SUBMITTAL DATA

Job Name Eli Lilly B10 Bypass Room Fan Filter Unit

For Messer Construction

Daikin Air Handler Packaged Fan Selection

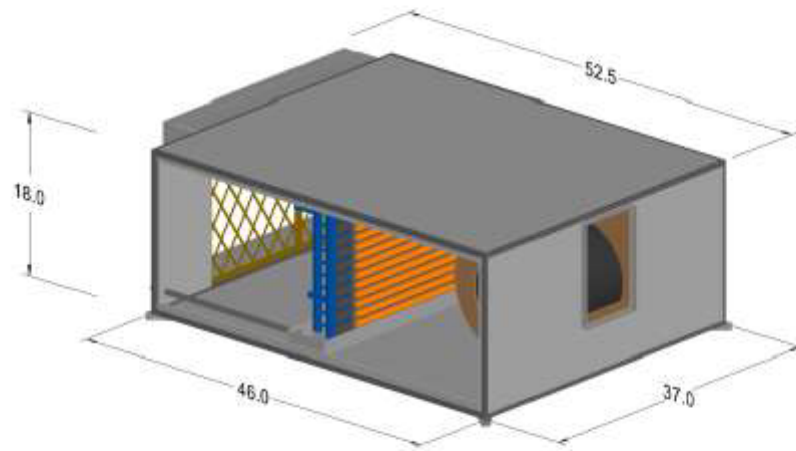
MNA: PLEASE RESELECT FAN TO MOVE OPERATING POINT TO THE RIGHT. THIS MIGHT MEAN A SMALLER FAN. FEEL FREE TO REACH OUT TO MNA DIRECTLY TO DISCUSS THE FAN OPTIONS.

Plan View - Mounting

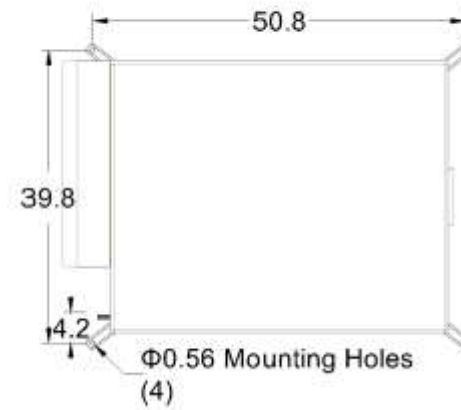
Prepared By Evan Nutt MNA: UNIT WILL BE INSTALLED ON CONCRETE PAD.
